Subject: **Addendum - Remedial Investigation Work Plan**
Tioga Avenue BCP Site# C851031
Corning, New York

TIOGA AVENUE SITE #C851031

SUMMARY OF CORNING INCORPORATED RESPONSES TO NYSDEC AND NYSDOH COMMENTS ON THE RIWP DATED AUGUST 18, 2009 AND ADDENDUM TO THE REMEDIAL INVESTIGATION WORK PLAN (as revised April 2009)

FIGURE 6

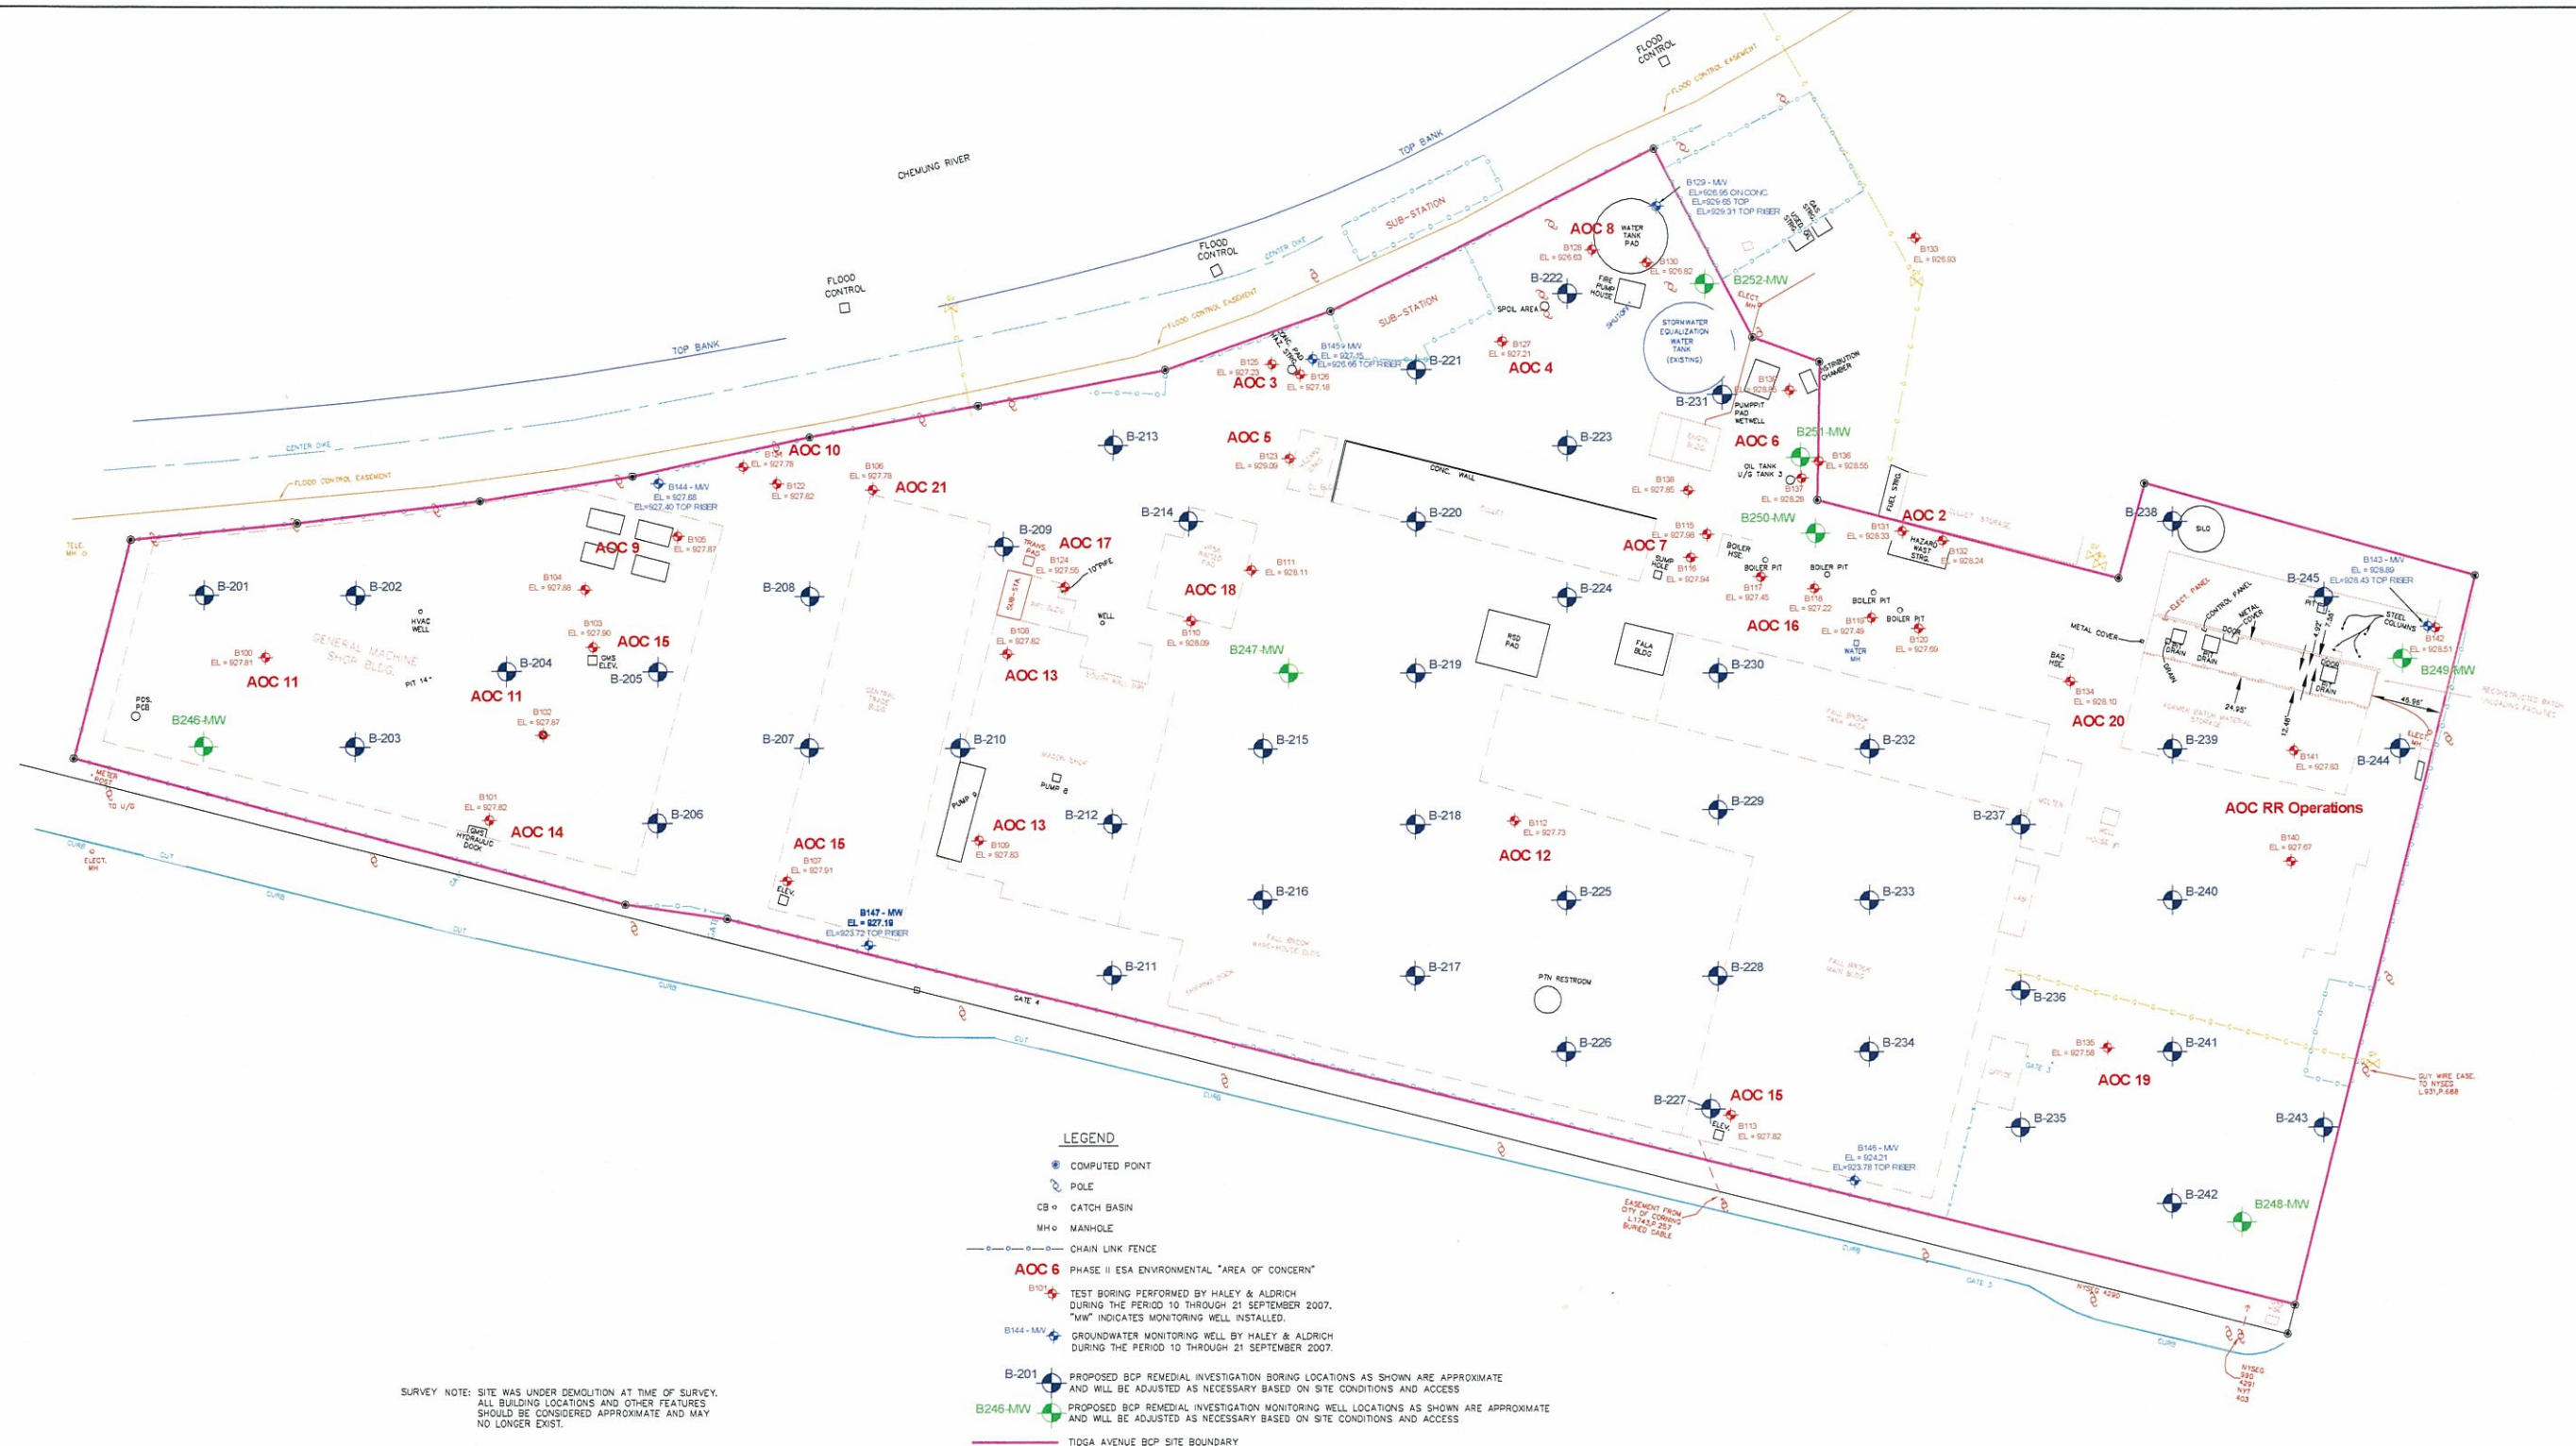
Response Letter Item #3 – As indicated in your response and documentation, trichlorethene (TCE) was detected in 1990 in the former Pressware Drinking Water Supply at levels of 22 ppb, significantly higher than the Maximum Contaminant Level of 5 ppb. This resulted in abandonment of this supply as a potable water source and ultimately resulted in connection to the City of Corning's Public Water Supply. No records, however, have been provided indicating when that physical connection was made. Repeat sampling conducted in 1992 indicated that levels of TCE, at that time, met State Sanitary Code regulations, but no confirmation exists whether the source of supply tested at the time was from the municipality or an on-site well. In review of the ESA, the Source Water Assessment Area diagram currently locates three wells, within one mile of the site, two upgradient and one down gradient. As requested in the original RIWP review, but determined through our investigation, is the fact that three municipal wells, located downgrade from the site, between 1200 and 500 feet in distance were abandoned by the City of Corning due to TCE contamination. These wells were screened at depths of approximately 60'-70' bgs which is comparable to the screened depth of the designated wells #1 and #2. In comparison, monitoring well B143-MW, positioned near the #1 well to investigate the presence of TCE in this area's groundwater, was drilled only to a depth of 28'. Please relocate the proposed BCP monitoring well, shown near the eastern property line, to the area of Well #1 and set the screened depths comparable to Well #1 and the referenced municipal wells. Also, please install a monitoring well with similar specifications in the Southeast corner of the BCP site and specify the site's centrally located monitoring well with the same installation specifications.

Item #10, #28, Section 5.1 – As previously requested, and to adequately characterize the site vertically, we are requesting that all borings will minimally extend to groundwater level. Please remove “will generally be advanced to the top of un-impacted native soil”, and “if any evidence of contamination is observed....,” indicating otherwise. Also, you have indicated that up to 26 additional borings will be installed on the basis of “conditions” observed in the field. The conditions have not been specified nor prioritization of the additional locations discussed. Please indicate that placement of the additional borings is subject to decision, and/or pre approval and acceptance by representatives of this Department.

Item #20 – A sample from B113 was not analyzed and a PID malfunction was logged on this boring. Please site a boring in this area to confirm AOC-15 as not an area of concern.

Item #22, Section 4.3.16 – Please locate a boring in the substation and transformer pad proximity and include analysis for PCB's in addition to the proposed wipe samples.

- The proposed new well located at the eastern property line will be moved to the area of Well #1 which is shown as well B249-MW on the attached Exploration Location Plan, Figure 6, as revised August 2009, which replaces Figure 6 in the RIWP, as revised April 2009. This new well will be installed in accordance with the procedures specified in the RIWP except that the total well depth will be 70 feet below ground surface (bgs) with the well screen set from approximately 60 feet to 70 feet bgs.

- The proposed new well located in the center of the Tioga Avenue site (identified on Figure 6, as revised August 2009, as well B247-MW) will be extended to a total well depth of 70 feet below ground surface (bgs) with the well screen set from approximately 60 feet to 70 feet bgs.

- An additional well will be located in the southeast corner of the BCP site identified as well B248-MW on Figure 6, as revised August 2009. This well will be completed the same as the above wells with a well screen set from approximately 60 to 70 feet bgs.

Hydraulic oil does not contain volatile compounds that would be detectable using a PID, therefore visual observation is the primary sample screening method. Section 5.1 of the RIWP is revised to indicate that a boring will be placed (and sampled) next to the former elevator in accordance with the Department's request (refer to boring B-227 on Figure 6, as revised August 2009 and to Table 8 as appended to the RIWP).

Section 5.1 of the RIWP is revised to indicate that a boring will be located and sampled for PCBs that is proximate to the substation and transformer (refer to boring B-209 on Figure 6, as revised August 2009 and to Table 8 as appended to the RIWP).

FIGURE 7

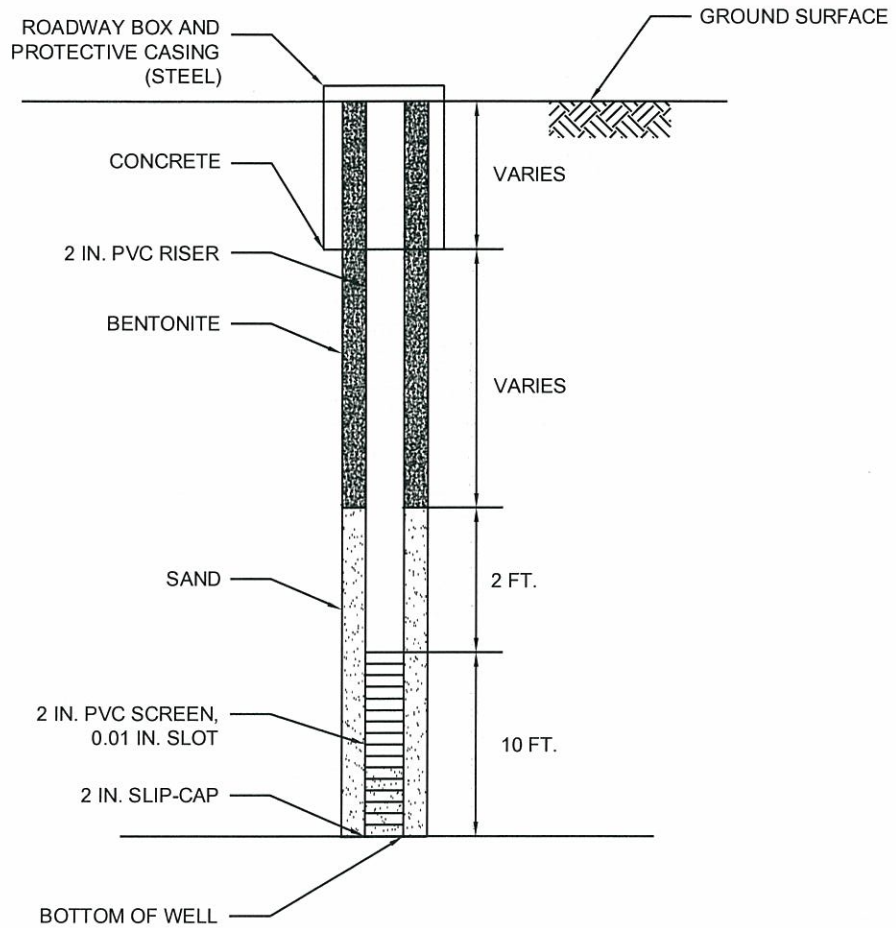
Section 5.2 – In reference to monitoring well installation, please include a well construction drawing providing detailed design information including material specifications, backfill material, thicknesses, seal thicknesses, screen positioning in relationship to groundwater depths, etc.

The proposed new wells will be completed as shown on the schematic drawing identified as Figure 7 as appended to the RIWP.
